Affinity At Albuquerque Senior Housing - McMahon & Finland

Drainage Plan for Site Development for Building Permit

Re: Affinity at Albuquerque Senior Housing, Hydrology Re-Submittal

DRAINAGE MANAGEMENT PLAN

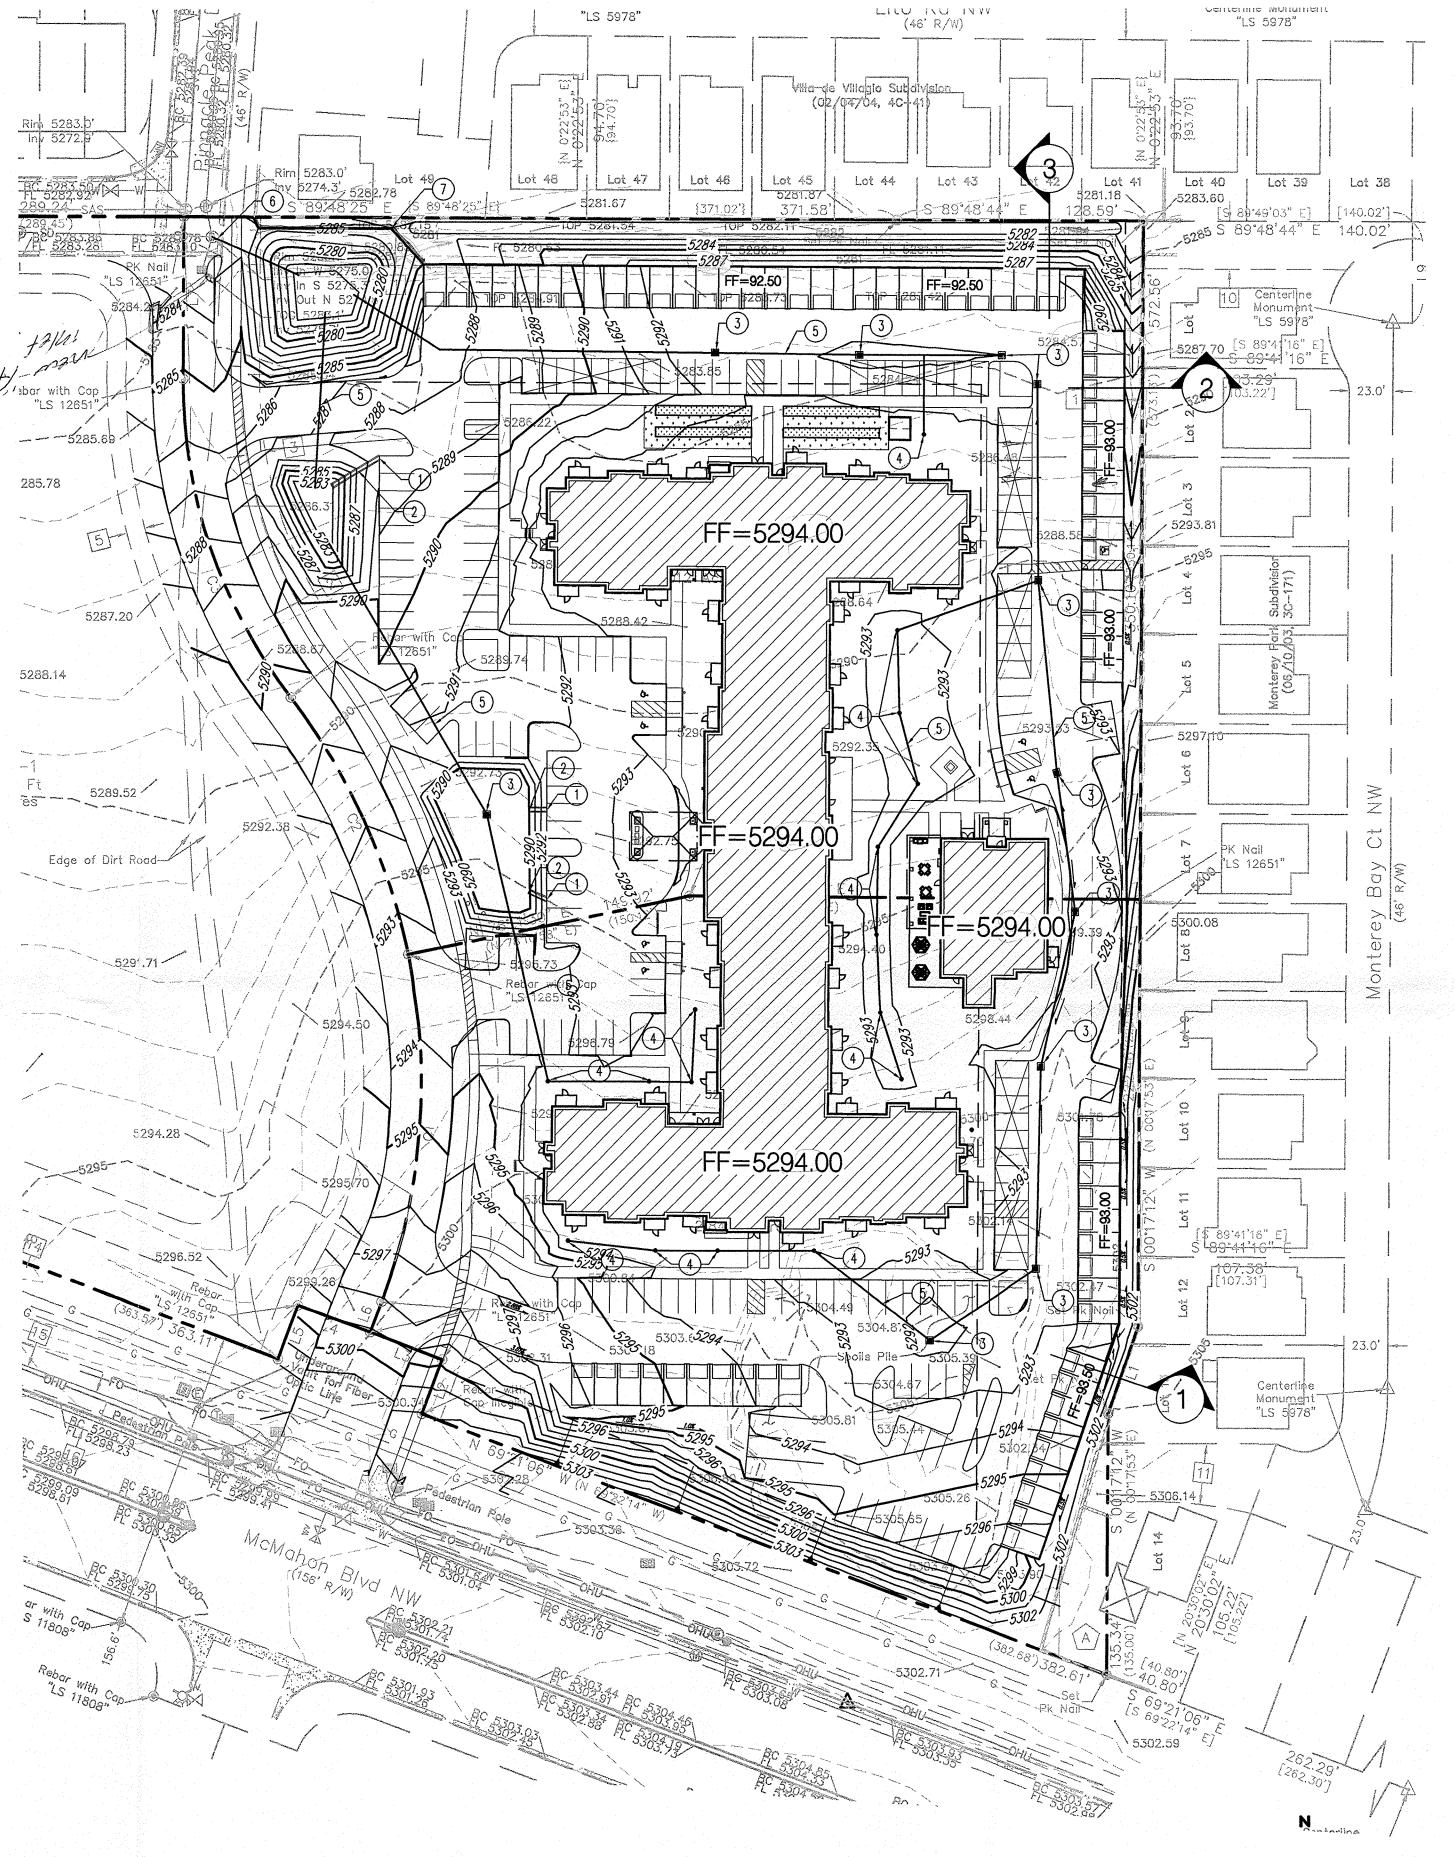
3. Pond #2 would overflow into Basin 5 as shown. Is the concrete wall intended to separate Pond #2 and Basin #5? Indicate the extents of the concrete retaining wall that is intended to prevent flow to property to the north.

4. Basin #5 along north side of property appears to act as a retention pond. Please provide pond volume calculations and WSEL. How is emergency overflow handled for this pond.

- 1. Included in this re-submittal is a copy of the vacation action exhibit showing the 25' pedestrian access easements to be vacated (DRB #1000875).
- 2. Carports will drain to the parking lot. Garages shown in the cross-sections on the grading plan will also drain to the parking lot. Roof gutters have been shown in the revised cross-sections.
- 3. The wall is intended to separate Pond #2 and Basin #5. The grading plan has been updated to better graphically represent the extent of the wall.
- 4. Basin #5 contains a shallow water harvesting area along the north portion of the property. Pond volume and water surface elevation calculations have been provided on the drainage management plan. The water harvesting area was sized to fully retain the 100 year 10 day storm. Calculations for the runoff volume are provided on the updated DMP.

POND 2 IS LOCATED AT THE NORTHWEST CORNER OF THE STREET. THE PRIMARY DISCHARGE POINT FOR POND 2 IS A NEW STORM DRAIN TO BE CONNECTED TO AN EXISTING PUBLIC STORM DRAIN MANHOLE AT THE INTERSECTION OF PINNACLE PEAK AND CROWN ROAD. IN THE EVENT THAT THE DISCHARGE PIPE IS PLUGGED, OR IN THE EVENT OF A STORM LARGER THAN THE 100 YEAR STORM, THE POND WILL OVERFLOW TO THE RIGHT-OF-WAY OF FINELAND DRIVE (AKA PINNACLE PEAK). UNDER EXISTING CONDITIONS, THE TOP OF CURB ELEVATION OF PINNACLE PEAK AT THE INTERSECTION WITH CROWN ROAD IS APPROXIMATELY 5283.78. THE EXISTING GRADE ALONG THE NORTH PROPERTY LINE OF THE SITE (DELINEATED WITH AN EXISTING CMU WALL) WHICH ADJOINS EXISTING RESIDENTIAL LOTS, VARIES BETWEEN 5281 AND 5282. THEREFORE, THE EXISTING GRADE ALONG MOST OF THE NORTH PROPERTY LINE IS ABOUT 2' LOWER THAN THE TOP OF CURB OF PINNACLE PEAK. IN ORDER TO ENSURE THAT ANY OVERFLOW FROM POND 2 DOES NOT IMPACT THE RESIDENTIAL LOTS TO THE NORTH, WE ARE PROVIDING A CAST-IN-PLACE CONCRETE WALL ALONG

THE NORTH SIDE OF POND 2. THE WALL WILL BE APPROXIMATELY 3' TALL, WITH A TOP-OF-WALL ELEVATION OF 5285.0.

BASIN 5 CONSISTS OF SMALL LANDSCAPED AREAS BEHIND THE GARAGES ON THE NORTH SIDE OF THE SITE AND A SMALL PORTION OF THE EAST SIDE OF THE SITE. THERE IS NO IMPERVIOUS AREA WITHIN BASIN 5. ALL OF THE GARAGE ROOFS DRAIN TO THE PARKING LOTS AND DRIVEWAYS. FLOWS FROM BASIN 5 (PEAK DISCHARGE IS LESS THAN 1.0 CFS) WILL BE RETAINED IN A SHALLOW, WATER HARVESTING AREA WITHIN THE LANDSCAPED AREA NEAR THE NORTH PROPERTY LINE.

GRADING PLAN

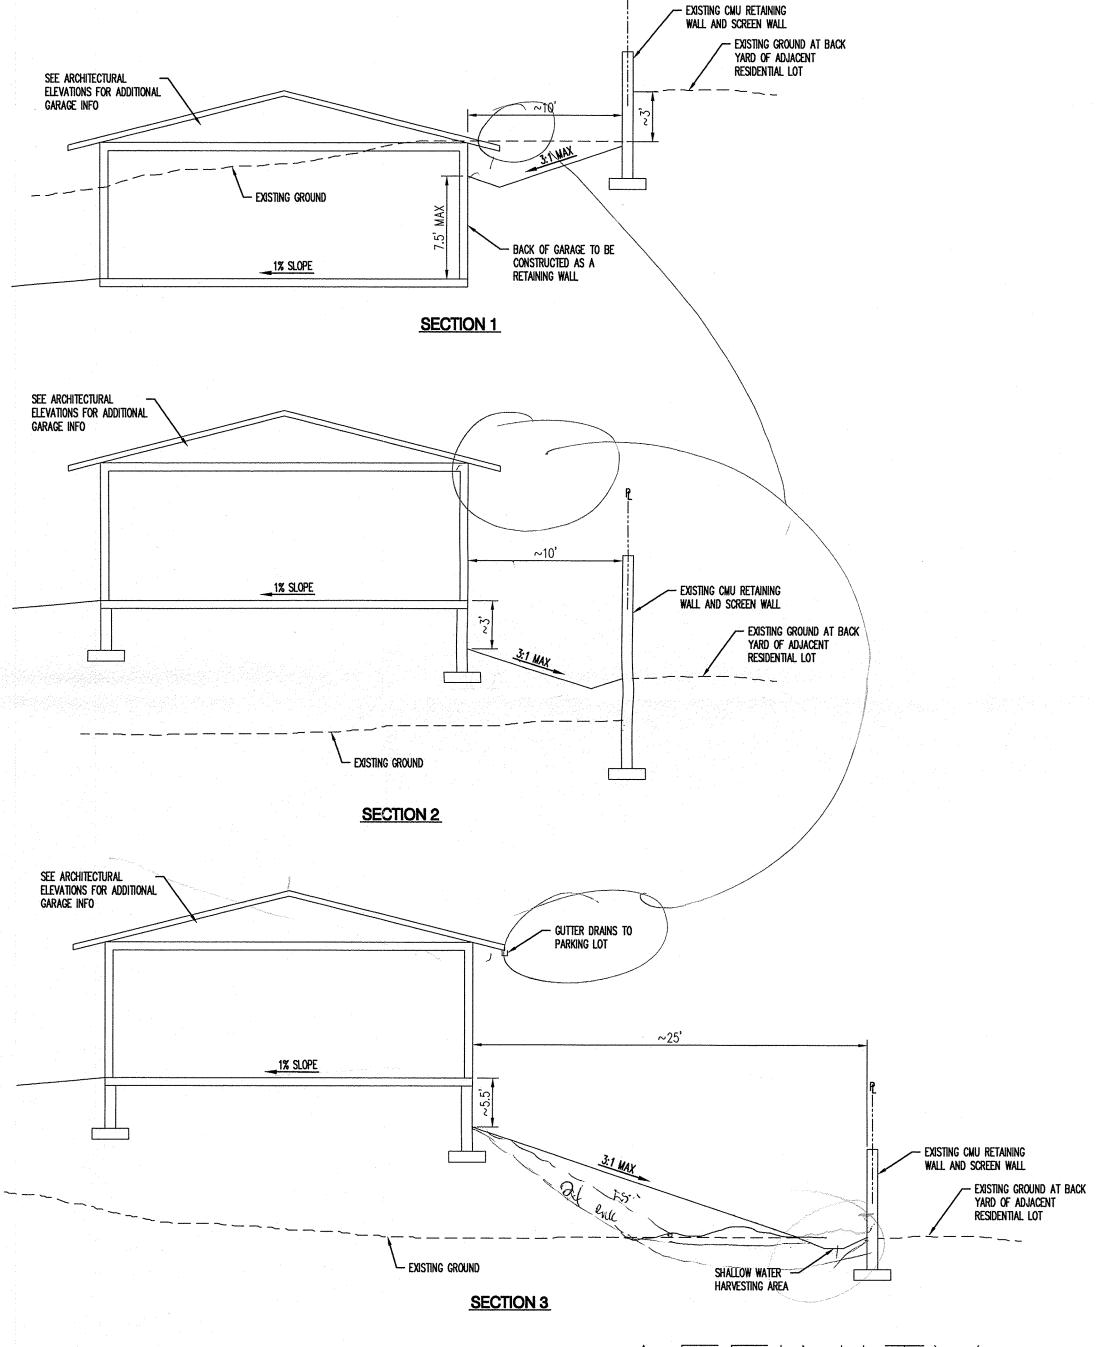
- 1. Plat indicates 25' pedestrian access easement on north and east boundaries. Water harvesting areas do not accommodate pedestrian access at the given slopes. Is the intent to vacate the easement? Is the intent to vacate the utility easements as well?
- 2. If the intent is to drain the carport to the parking lot, roof gutters should be shown on all cross-sections.

7. CAST-IN-PLACE CONCRETE WALL. TOP OF WALL ELEVATION = 85.0
